Title of Change:	Transfer of Assembly and Test operations of Cebu former Fairchild SC70 package to ON Semiconductor Leshan, China and change the backmetal site from Bucheon, Korea to ON Niigata, Japan.
Proposed Changed Material First Ship Date:	8 July 2020
Current Material Last Order Date:	31 March 2020 Orders received after the Current Material Last Order Date expiration are to be considered as orders for new changed material as described in this PCN. Orders for current (unchanged) material after this date will be per mutual agreement and current material inventory availability.
Current Material Last Delivery Date:	29 June 2020 The Current Material Last Delivery Date may be subject to change based on build and depletion of the current (unchanged) material inventory.
Product Category:	Active components – Discrete components
Contact information:	Contact your local ON Semiconductor Sales Office or < Joan.Abigail.Enriquez@onsemi.com >

文書番号# : FPCN22577Z

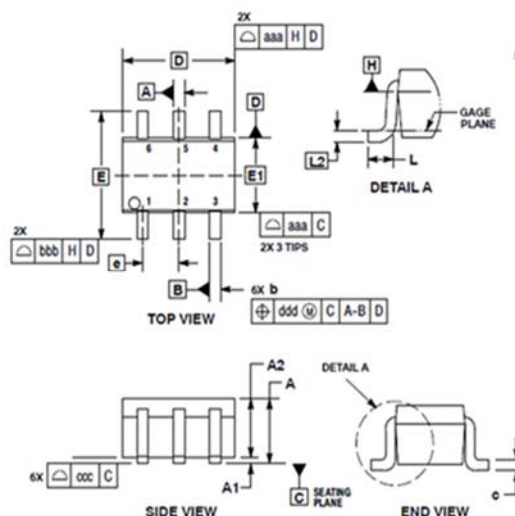
Case outline dimensions that is affected by the change is high lighted in Bold text:

CASE 419B (ON Leshan)			CASE 419AD		
Dimension	MIN	NOM	MAX	MIN	NOM	MAX
A	-	-	1.10	0.80	-	1.10
A1	0.00	-	0.10	0.00	-	0.10
A2	0.70	0.90	1.00	0.80	-	1.00
b	0.15	0.20	0.25	0.15	-	0.30
c	0.08	0.15	0.22	0.10	-	0.18
D	1.80	2.00	2.20	1.80	2.00	2.20
E	2.00	2.10	2.20	1.80	2.10	2.40
E1	1.15	1.25	1.35	1.15	1.25	1.35
e	0.65 BSC			0.65 BSC		
L	0.26	0.36	0.46	0.26	0.36	0.46
L2	0.15 BSC			0.15 BSC

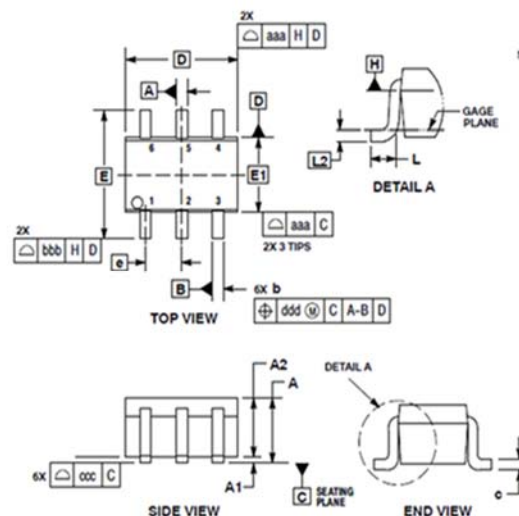
変更により影響を受けるケースアウトライン寸法は太字でハイライトされています:

Dimension	CASE 419B (ON Leshan)			CASE 419AD		
	MIN	NOM	MAX	MIN	NOM	MAX
A	-	-	1.10	0.80	-	1.10
A1	0.00	-	0.10	0.00	-	0.10
A2	0.70	0.90	1.00	0.80	-	1.00
b	0.15	0.20	0.25	0.15	-	0.30
c	0.08	0.15	0.22	0.10	-	0.18
D	1.80	2.00	2.20	1.80	2.00	2.20
E	2.00	2.10	2.20	1.80	2.10	2.40
E1	1.15	1.25	1.35	1.15	1.25	1.35
e	0.65 BSC			0.65 BSC		
L	0.26	0.36	0.46	0.26	0.36	0.46
L2	0.15 BSC			0.15 BSC
